ST LEONARDS SOUTH

REPORT TO COUNCIL

REVIEW OF CHARRETTE & DPIE REPORT

April 2020

Figure 3.4: Solar Access

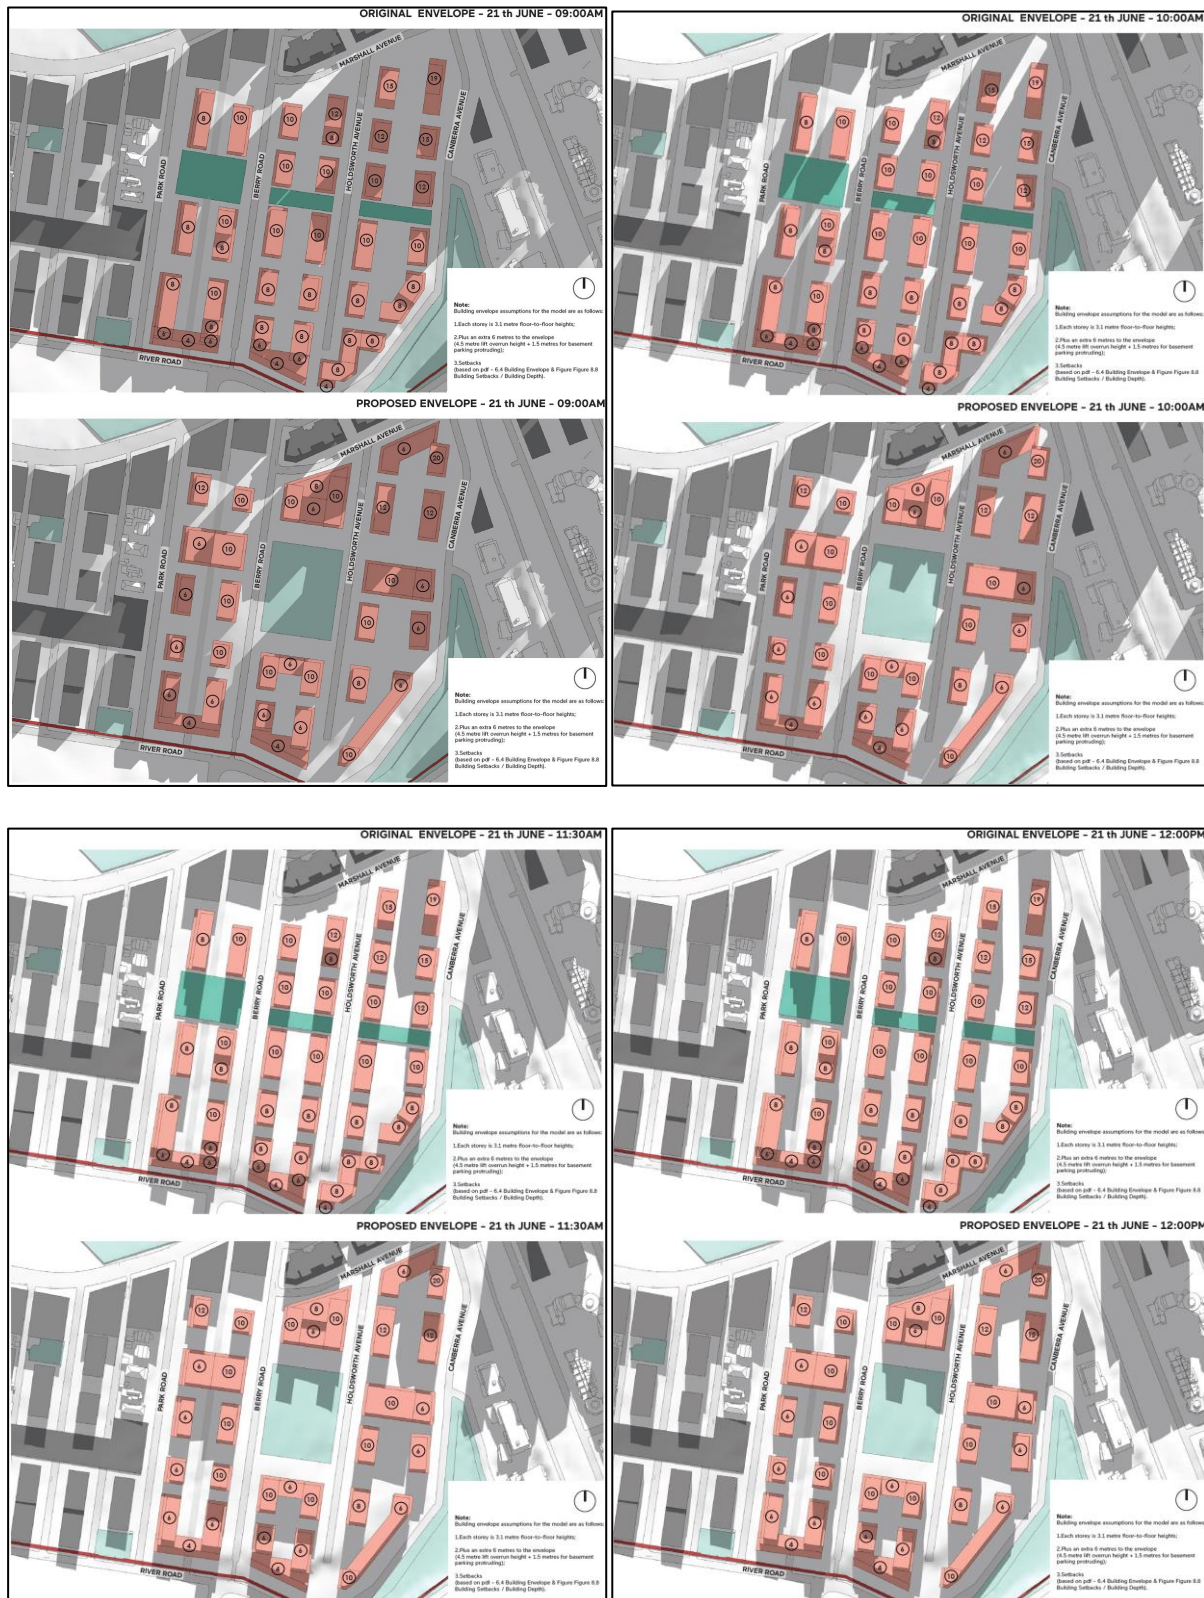
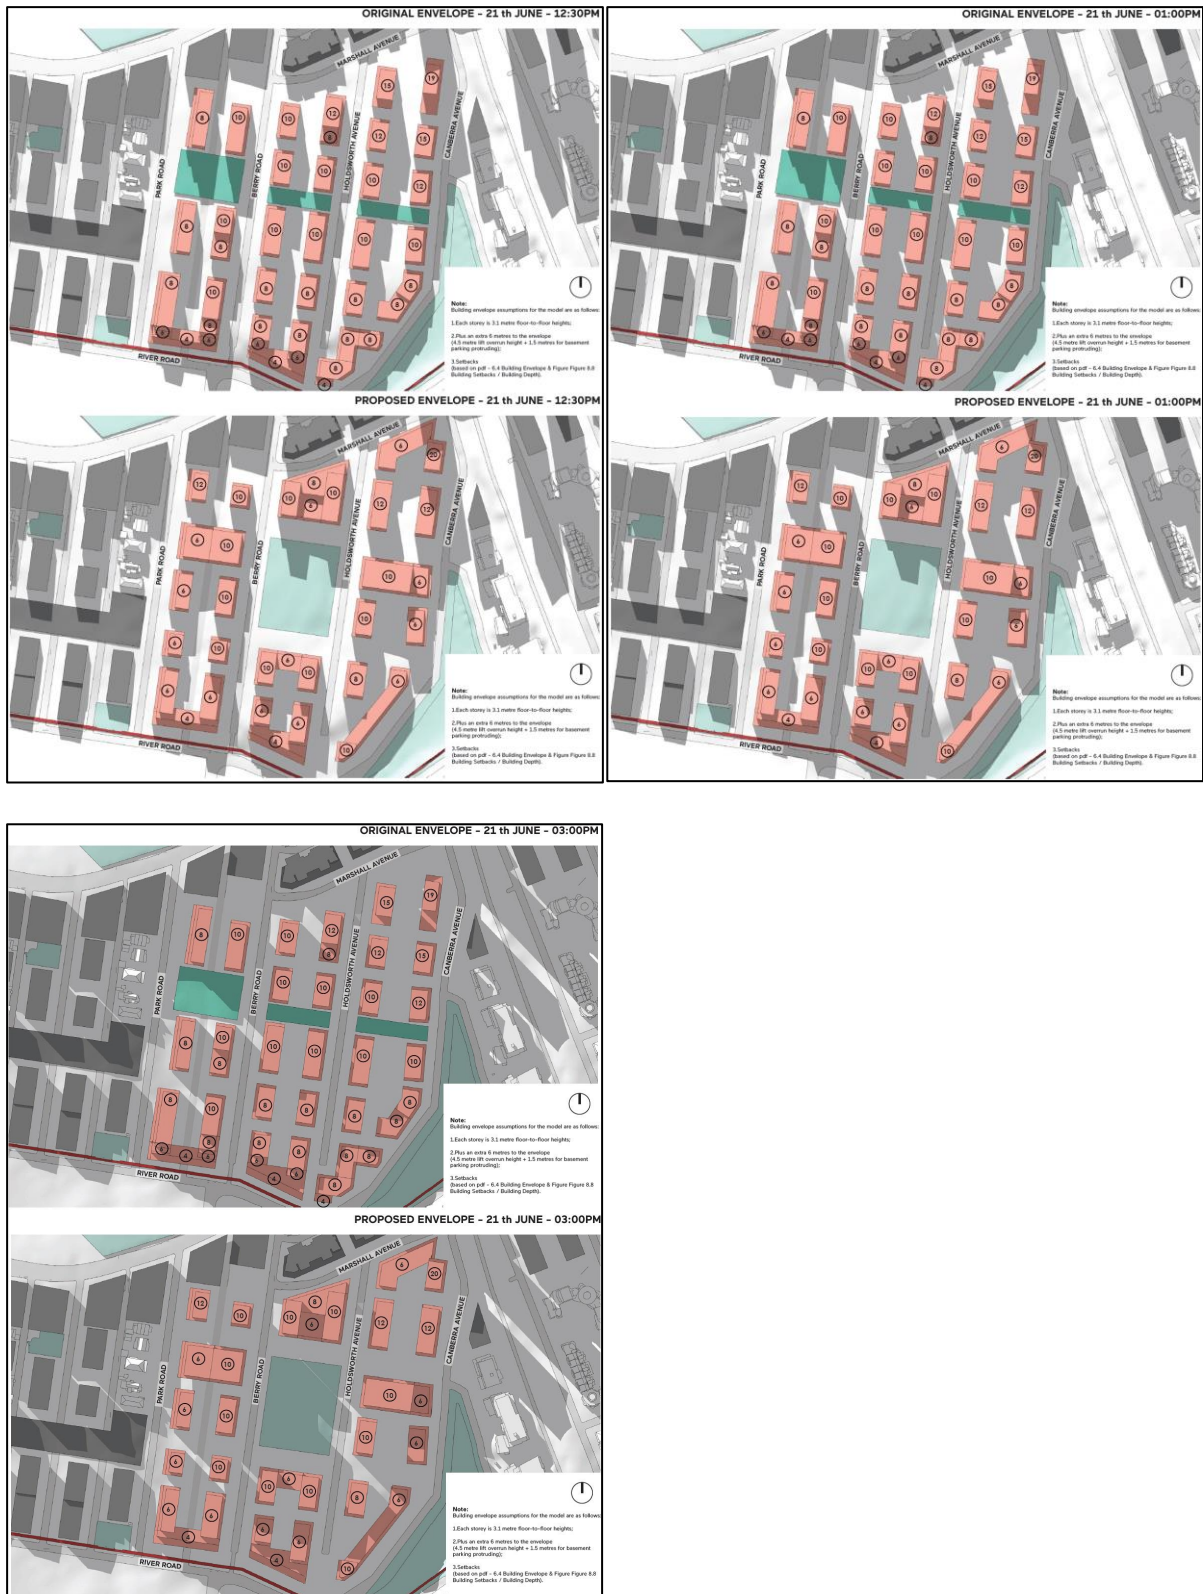
- Being consistent with the Apartment Design Guidelines, this is supported. Note, that the current heights proposed are generally ADG-compliant. Some further setbacks to park north buildings may be desirable. Larger scale versions of these diagrams are included in Appendix 1.

Note that solar access is similar for both Council's proposal and Charrette Proposal, except that the larger (and non-viable) park in the Charrette proposal provides greater solar access due to size.

Figure 3.6: Levels & Terraces (Planning Proposal)

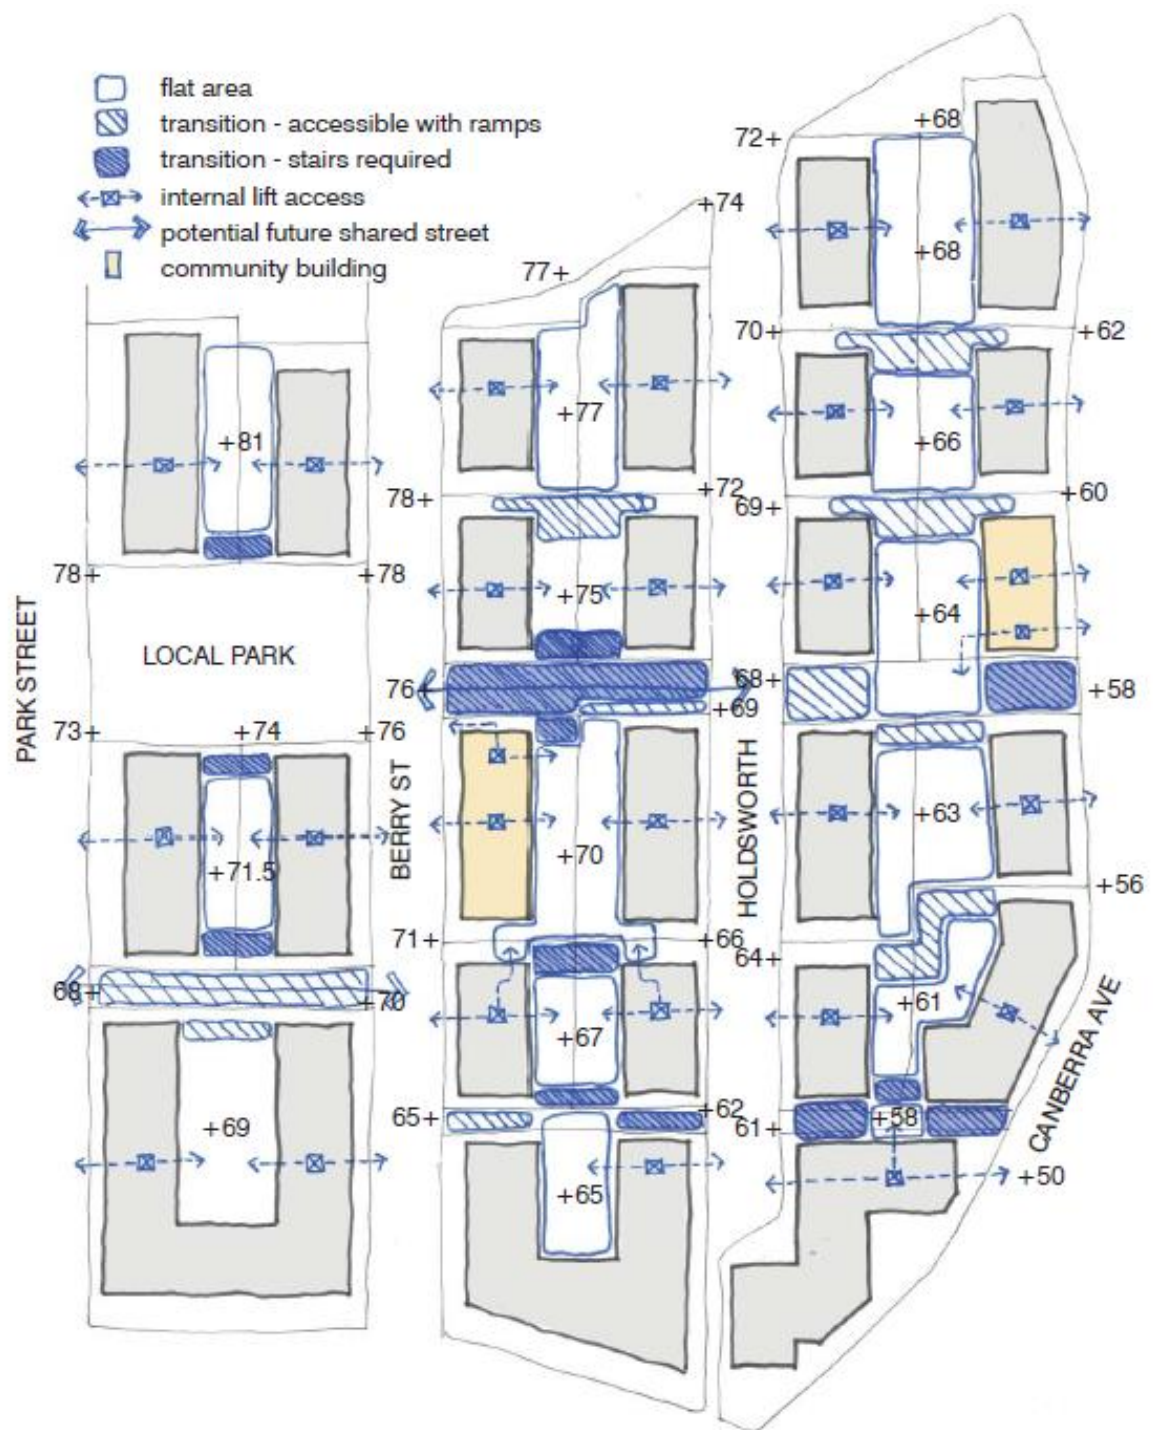
- Note that smaller block sizes will create problems with additional side setbacks and reduce development potential.
- Note that figure 3.6 explains the complex nature of site levels which facilitate optimum development, walkability and continuous, integrated "Green Spines".

Figure 3.7: Planning Proposal New Connections

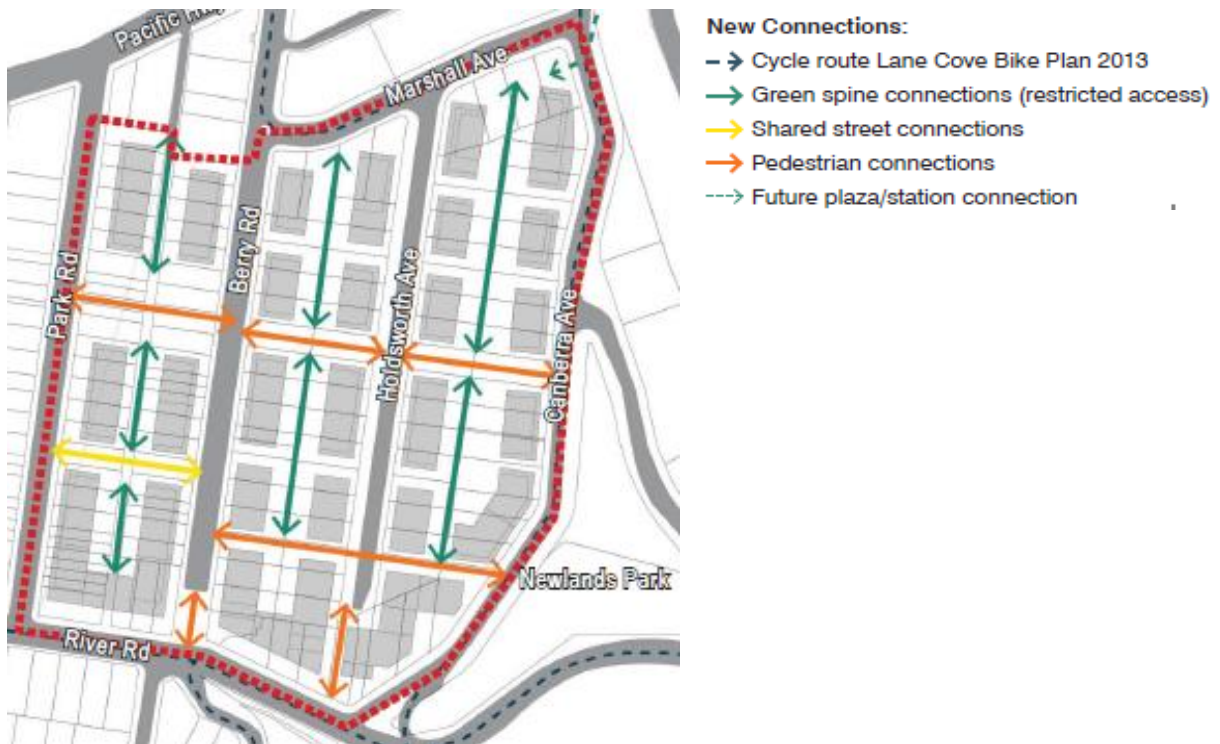
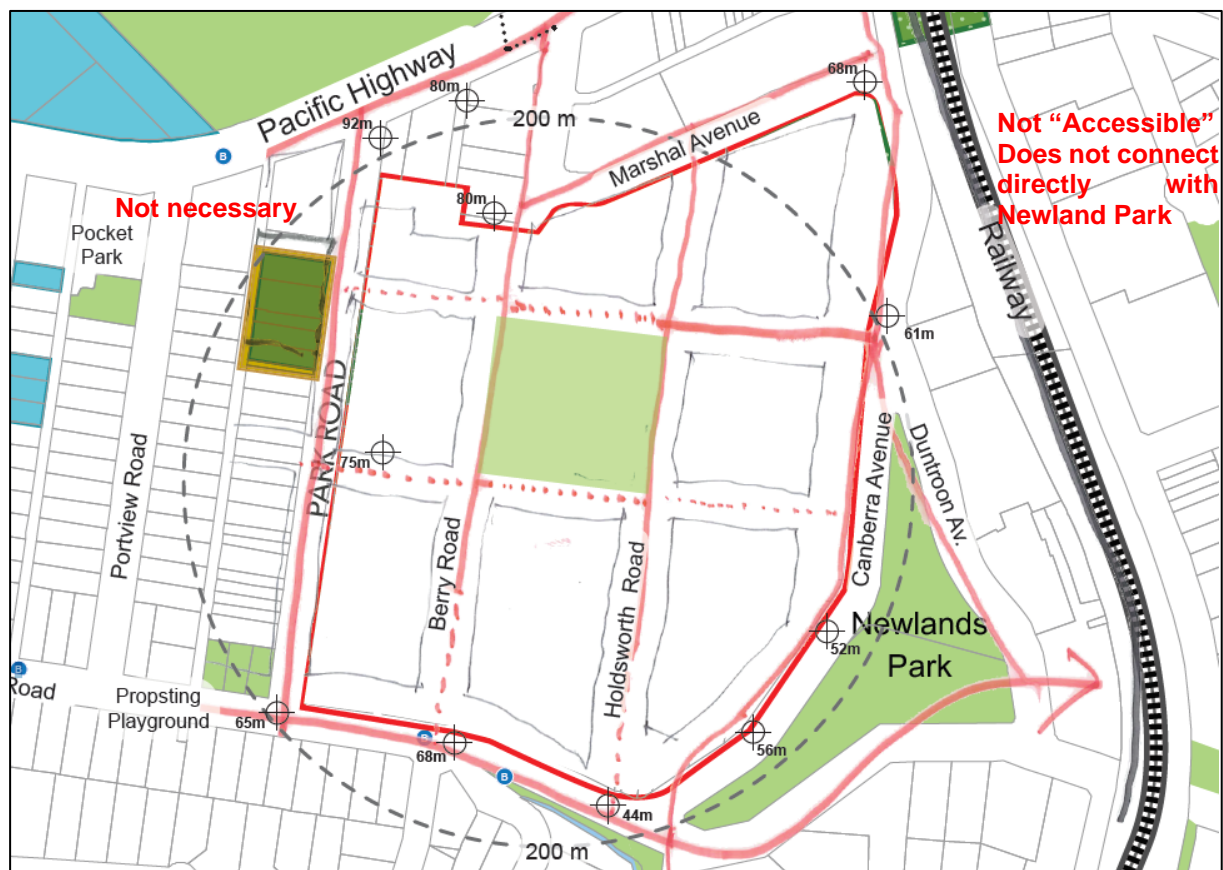
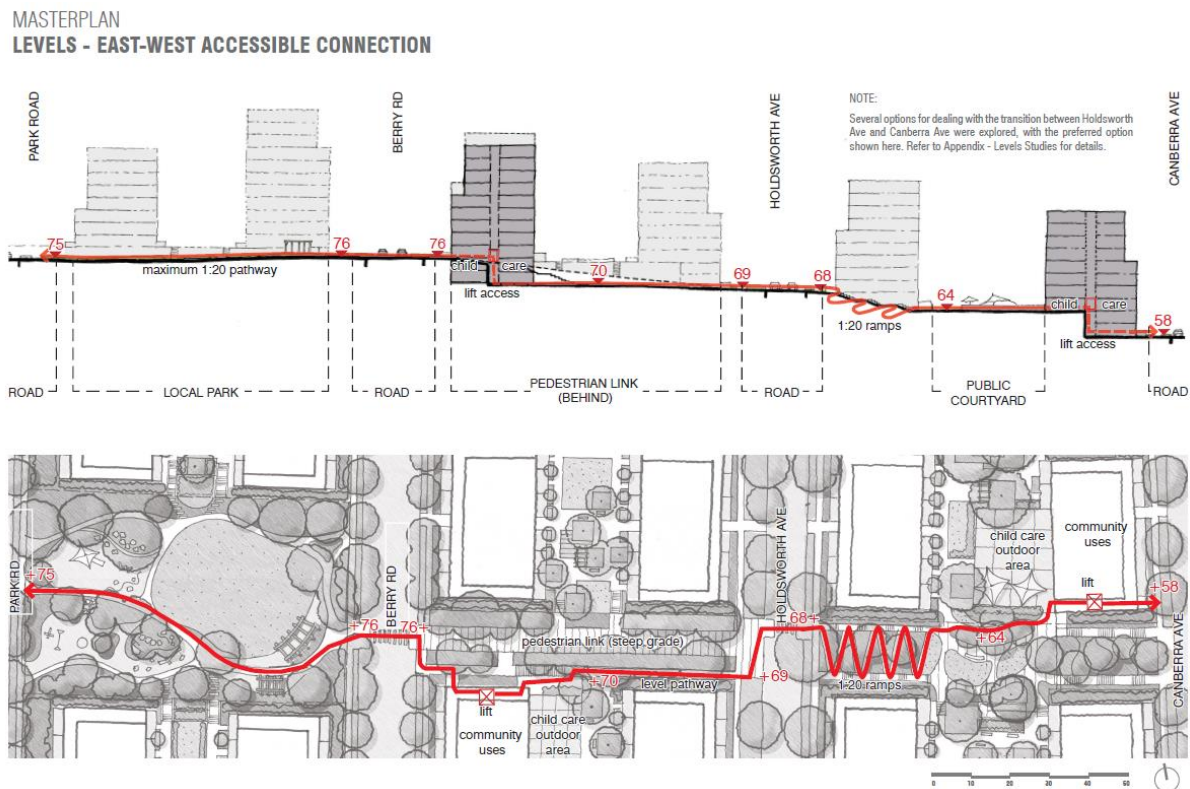
- In the Charrette Plan, the six east-west links are simply moved three or four lots north and widened in some cases. In effect, the walking journey to major destinations is the same, and is not improved. Need for (non-functional) grid system unclear.
- This also removes Council's coherent central east-west pedestrian link.
- Note that Council's E-W links are strategically located in order to:
 - connect major parks
 - optimise level changes/connections

- deliver pedestrians to N-S streets/footpaths to move toward rail station
- optimise capacity to integrate with community facilities and facilitate funding by development

Figure 4.3: Level Changes & Pedestrian Connection (Planning Proposal)

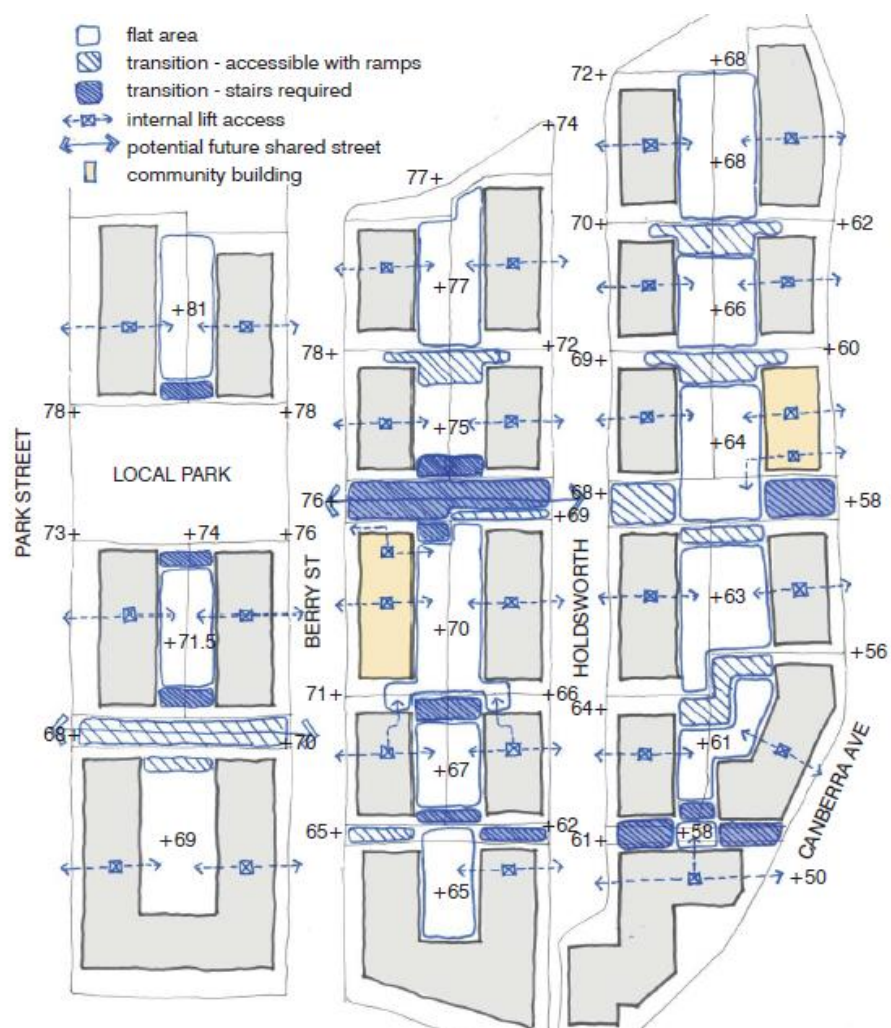
- There are numerous mature trees centrally located in these North-South Blocks (Back yards)
- They provide continuous integrated deep soil zones in each nominated development area, connecting with E-W links, accommodating level changes and providing a wide variety of communal opportunities for the use of residents.
- They provide for a green corridor for fauna/avifauna
- Provide opportunity for solar access into both the Green Spines and into adjacent overlooking buildings
- Provide a green outlook from adjacent buildings and ample building separation.
- Provide extensive opportunity for deep soil planting.

These are illustrated in location in figure 4.2 and integrated levels in figure 4.3.

Figure 4.9: Heights modified to achieve Charrette solar objectives to Newlands Park

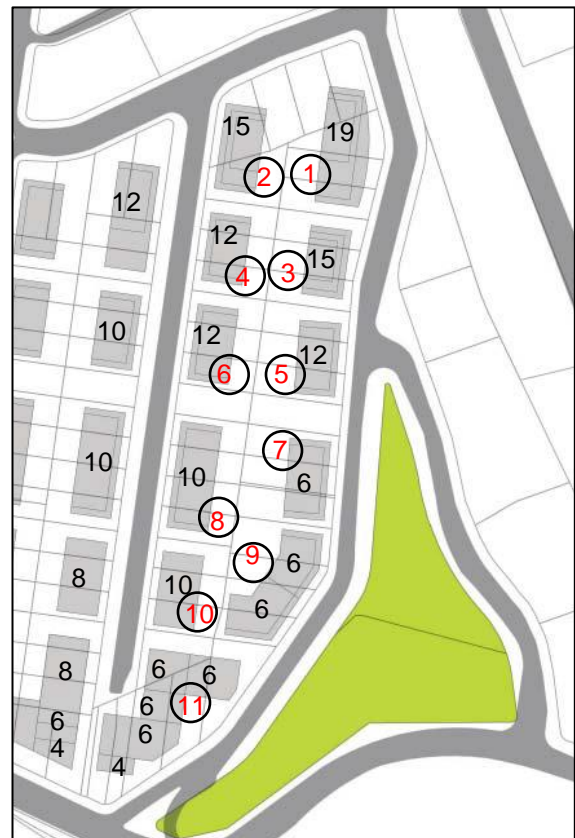
Parcel	Existing GFA	Council Height	Changed Height	Reduced GFA	Reduced FSR
7	8346	10	6	720/2782	0.26:1
9	6991	8	6	480/2542	0.19:1
11	11,198	8	6	960/4072	0.24:1

Figure 4.10: Planning Proposal Heights

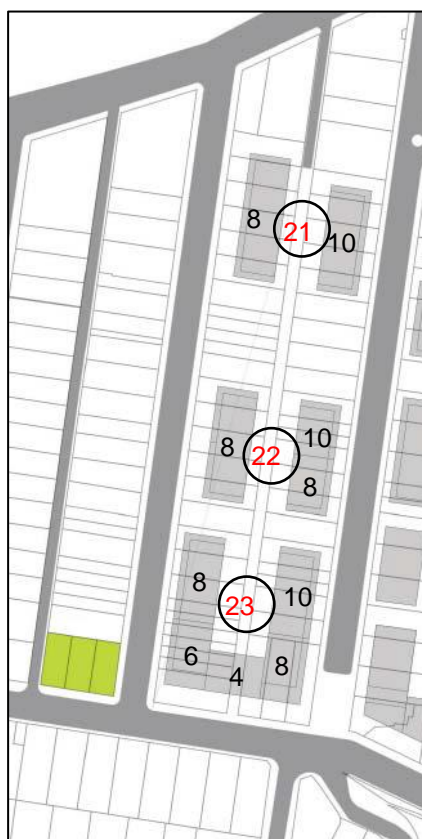
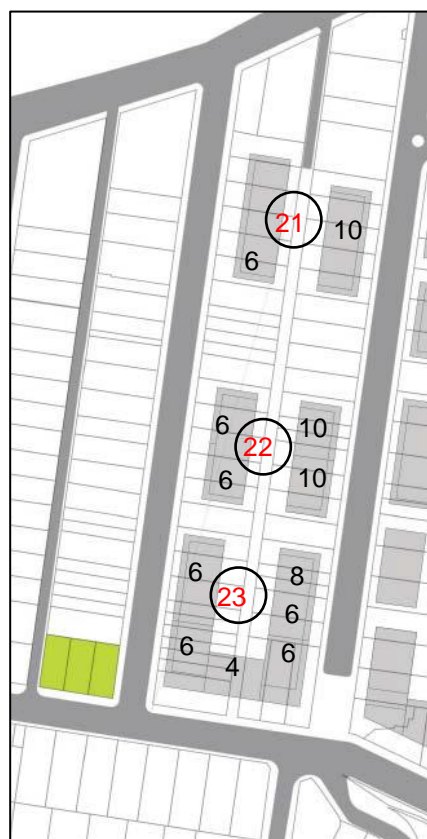
Parcel	Existing GFA	Council Height	Changed Height	Reduced GFA	Reduced FSR
21	5893	8	8	760/2000	0.3:1
22	7024	8	6	600/2000	0.3:1
23	8431	8	6	600/3000	0.2:1
